Re: **North Penn 5 Superfund Site, Operable Unit 2**
Report of Findings, Dated November 20, 2013 ("Report")

Re: Response to EPA Comments dated February 5, 2014
Regarding Report of Findings Dated November 20, 2013
Powertest Facility
North Penn Area 5, OU 2, Colmar, Pennsylvania

Figure 1
Powertest Facility Looking NE

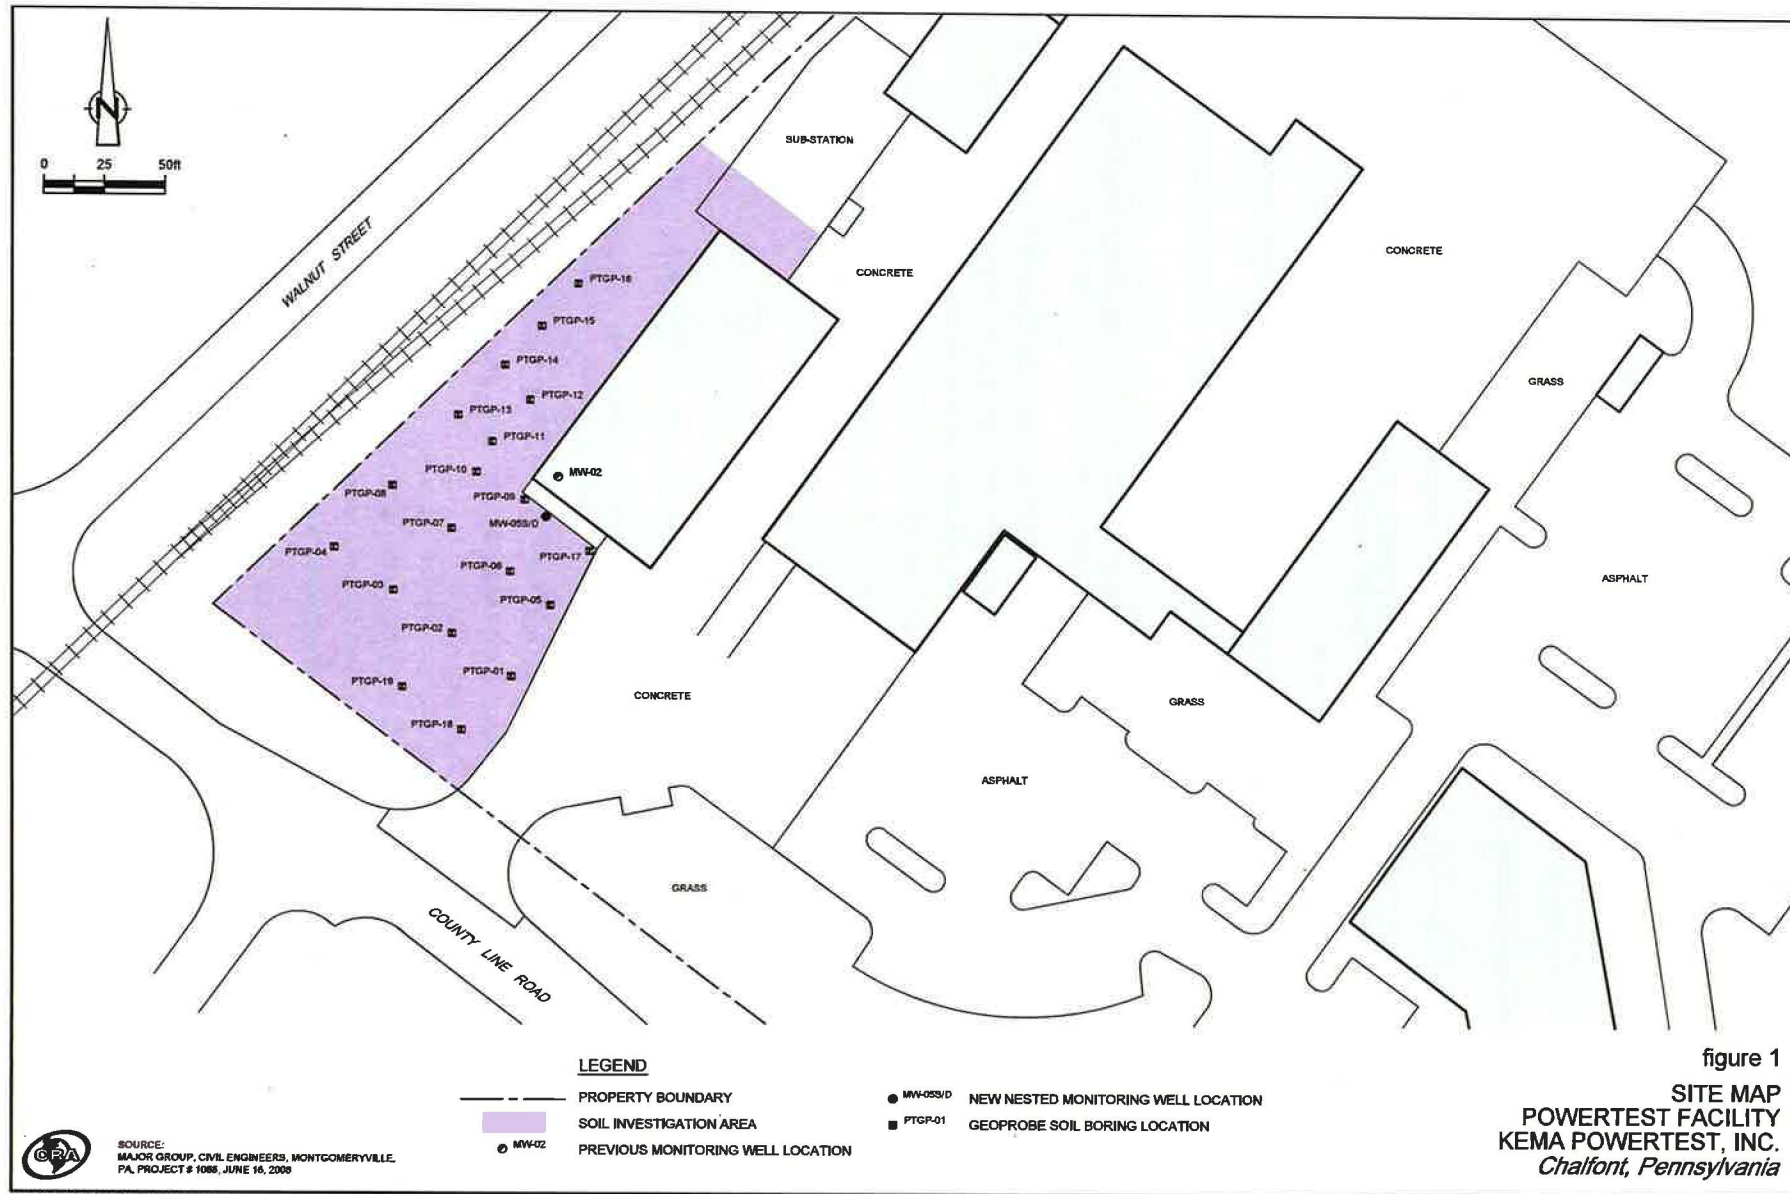
Given the upgradient location of the newly installed well, the use of the low flow sampling method without parameter stabilization, and the detections of two compounds associated with 1,1,1-TCA, along with the potential for contamination indicated by the high PID readings at the geoprobe locations on the apparent downgradient side of the building, the data do not fully support the Section 4 Conclusions presented. It is recommended that an additional well be installed at a location on the western side of the building, in a location near to and

downgradient of the abandoned well MW-02. In the event an additional well cannot be physically installed downgradient of the abandoned well MW-02, EPA would ask for documentation of the infeasibility of drilling a downgradient well. Further, if it is infeasible to install a well downgradient of the former MW-02 location, EPA would recommend that MW-05 be redeveloped and that a pump test of limited duration with time-series sampling be performed using MW-05.

Attached are some photos of the Facility. The 1st photo (Photo 1) is looking at the area northwest of the building from around the railroad track (view is to the northeast). This is the area which EPA believes to be hydraulically downgradient and suggested installing another monitoring well during the January 28th conference call. As seen on Photo 1, there is

limited space between the building and railroad to accommodate drill equipment and operate safely. Further, there are high voltage power lines running parallel to the railroad tracks and directly overhead. This area was reviewed by the driller in the field, and they noted that they could not drill in this area due to the limited access, nearby railroad, uneven terrain, and overhead power lines. The 2nd photo (Photo 2) shows the drillers air rotary drill rig and support vehicle. Both are large, and the drill rig boom when extended it ~30 feet high.

As noted above, it is not technically feasible to install a well in the downgradient direction of former well MW-02.
